**ADDENDUM NO. 2
TO
HAIKEY CREEK OPERATION AND MAINTENANCE
CAPITAL EQUIPMENT REPLACEMENTS
RMUA PROJECT NO. WPC 25-2
BAMA PROJECT NO. 2354170**

**ADDENDUM NO. 2
FEBRUARY 25, 2025**

**HAIKEY CREEK OPERATION & MAINTENANCE
CAPITAL EQUIPMENT REPLACEMENTS
RMUA PROJECT NO. WPC 25-2
BAMA PROJECT NO. 2354170**

203.200.A OPERATIONS LABORATORY & OPERATIONS ROOM REMODEL PLAN

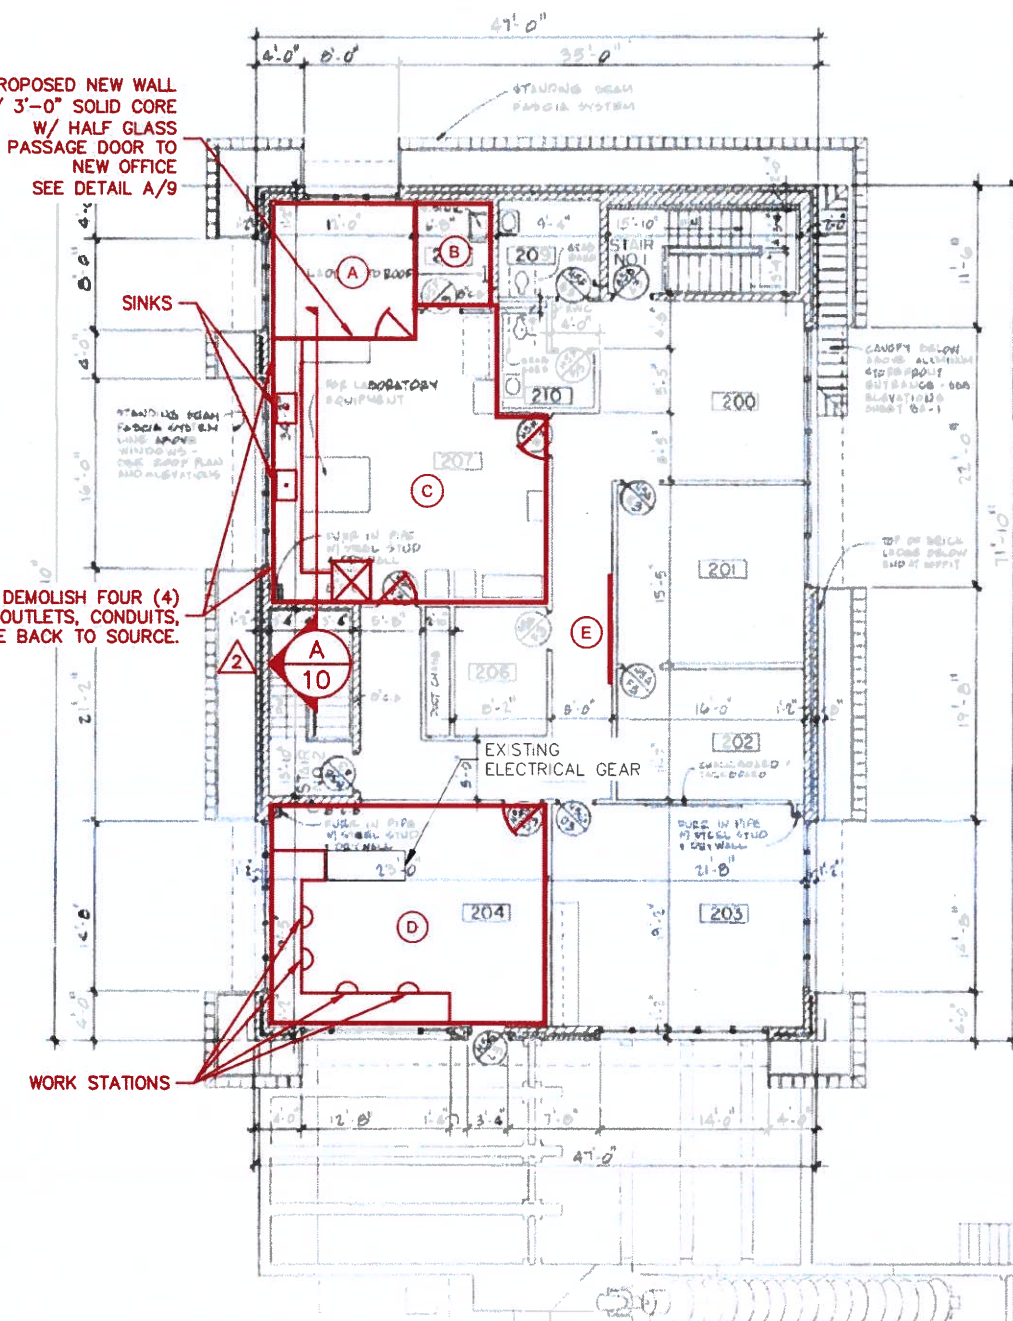
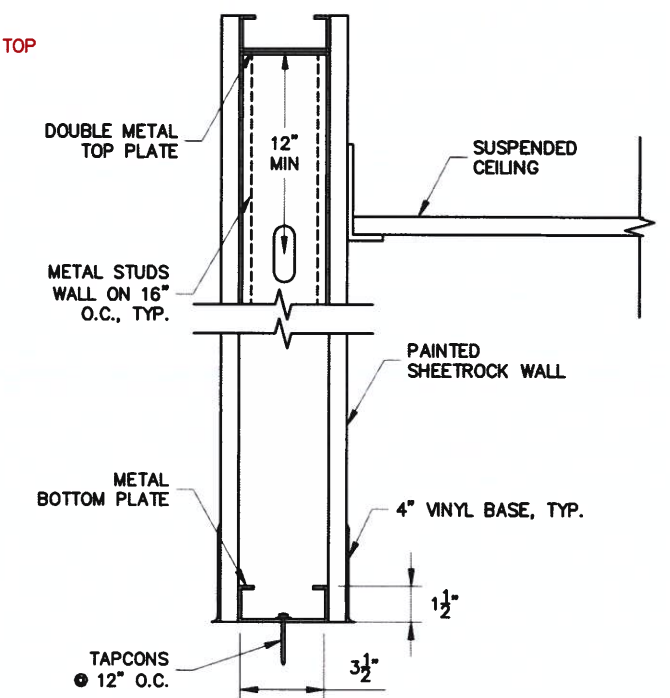
REVISION	BY	DATE
Δ ADDENDUM #2	TJR	2/25/25

ROOM FINISH SCHEDULE Δ

MARK	ROOM	FLOORING:	WALLS:	CEILING:	NOTES
A	PROPOSED OFFICE	REFURBISH	PAINTED, SEE NOTES	SUSPENDED ACOUSTIC	1, 2, 3, 4, 5, 8
B	CLOSET	REFURBISH	PAINTED, SEE NOTES	CONCRETE DECK	1
C	LABORATORY	REFURBISH	PAINTED, SEE NOTES	SUSPENDED ACOUSTIC	1, 2, 3, 4, 5, 6, 8
D	OPERATIONS ROOM	REFURBISH	PAINTED, SEE NOTES	SUSPENDED ACOUSTIC	1, 3, 4, 5, 8, 9
E	HALLWAY				7
